AMENDMENTS TO THE DRAWINGS

REMARKS

FIG. 1
(PRIOR ART)

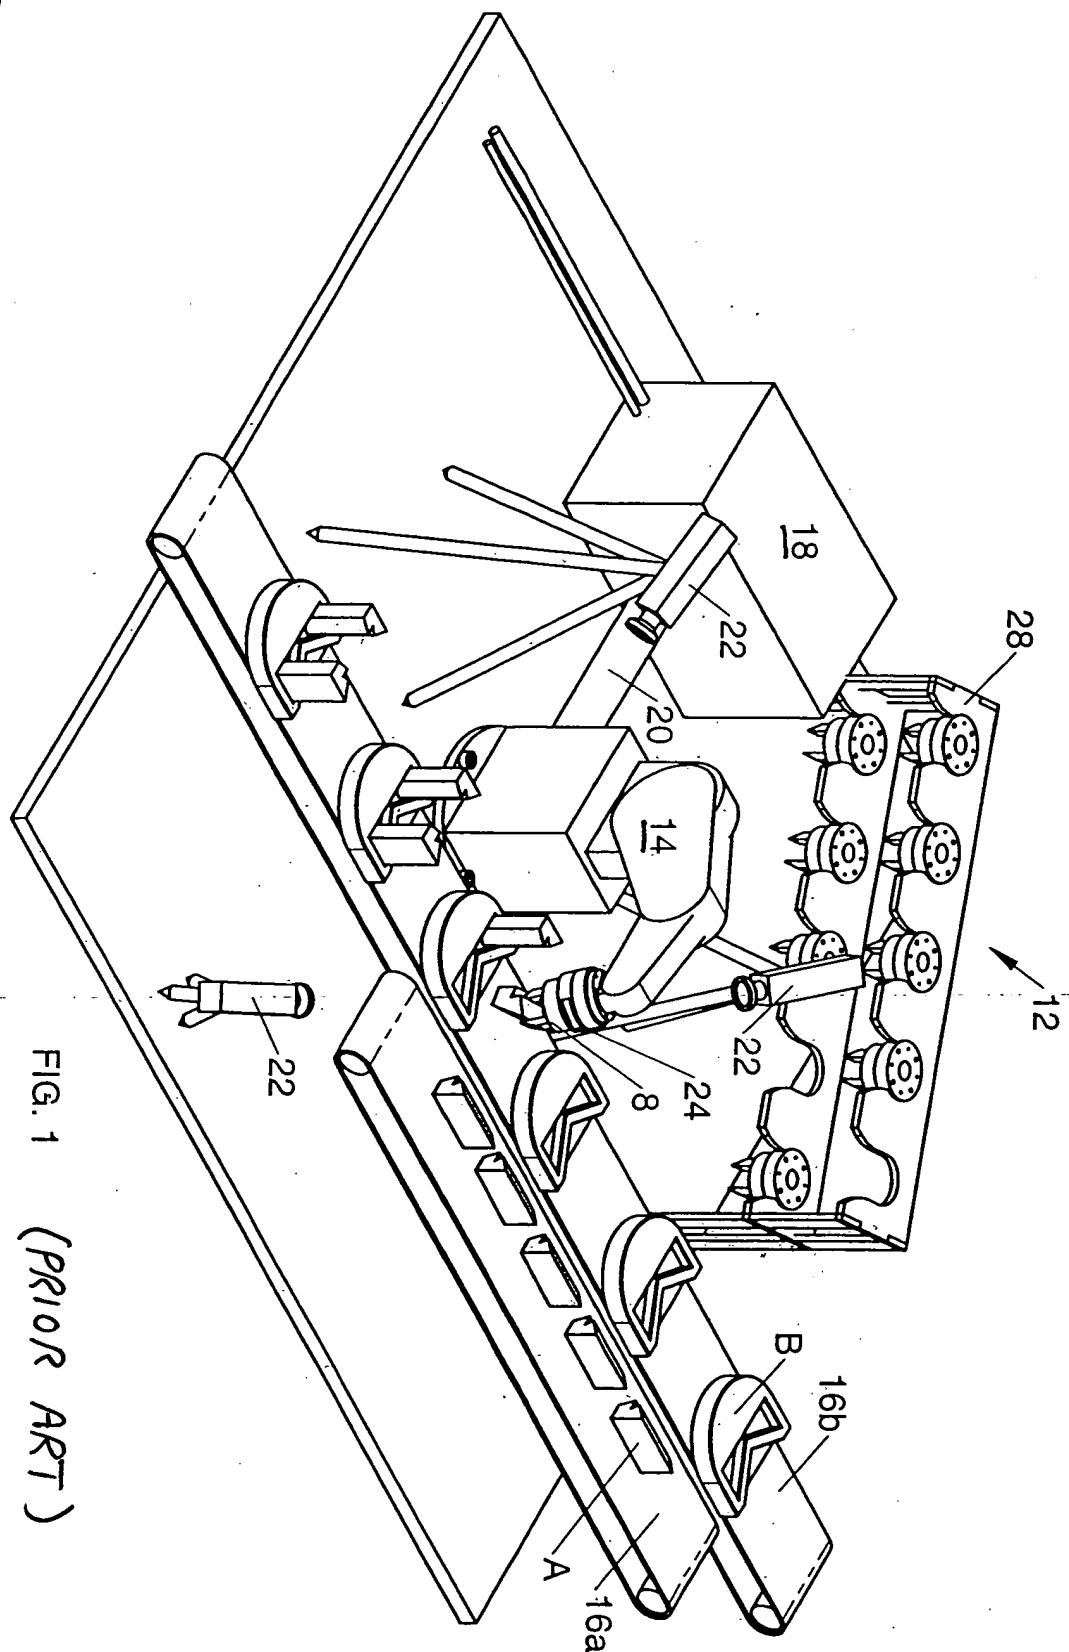
In Fig. 1, the legend "PRIOR ART" is added.

Fig. 1 does show a prior art system, and it is now so labeled, as suggested by the Examiner.

FIG. 4B

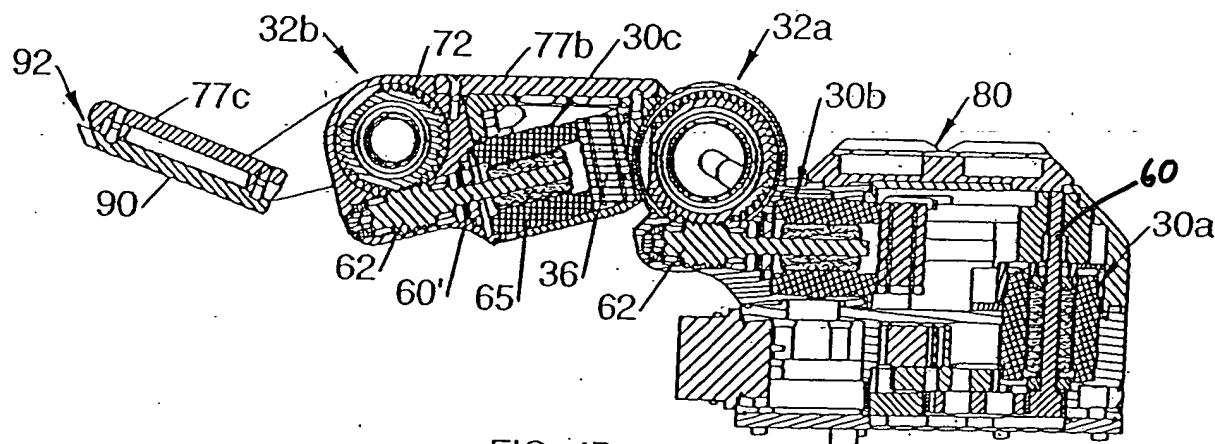
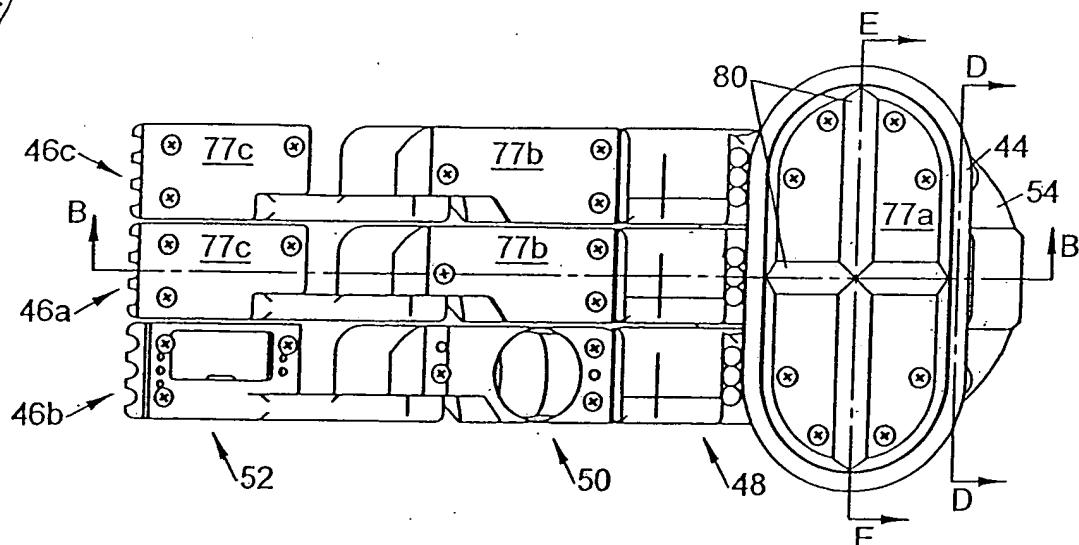
In Fig. 4B, reference number 60 is added to denote the rotor shaft of motor
30a.

Fig. 4B now has reference number 60 on the rotor shaft of motor 30a. (Rotor shafts for motors 30b and 30c are denoted 60'.)

FIG. 4C

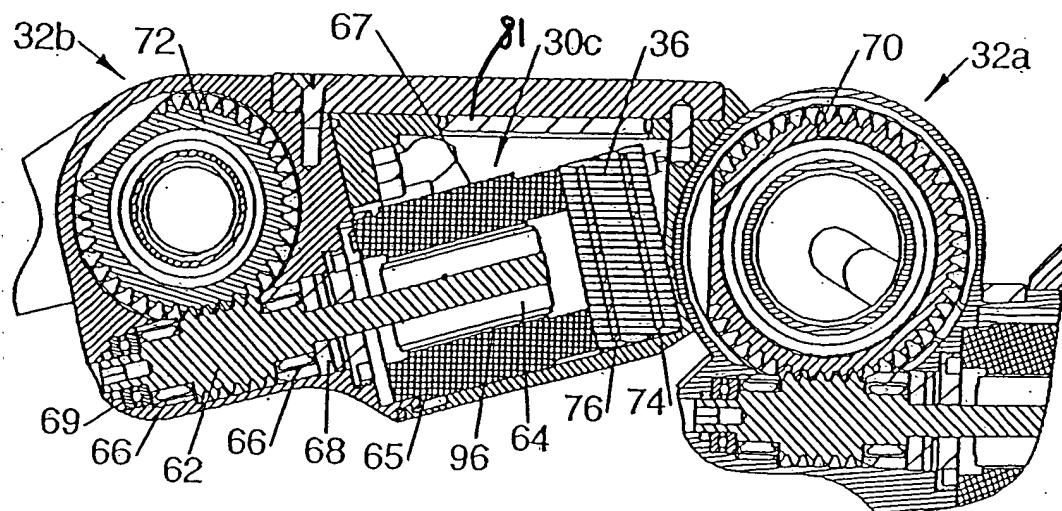
In Fig. 4C, reference number 81 is added to denote a cover.

Fig. 4C is amended to include reference number 81 (page 19, line 3) for a "man-hole like" cover under the replaceable gripping pad 77b, as described on page 18, line 15 to page 19, line 7.
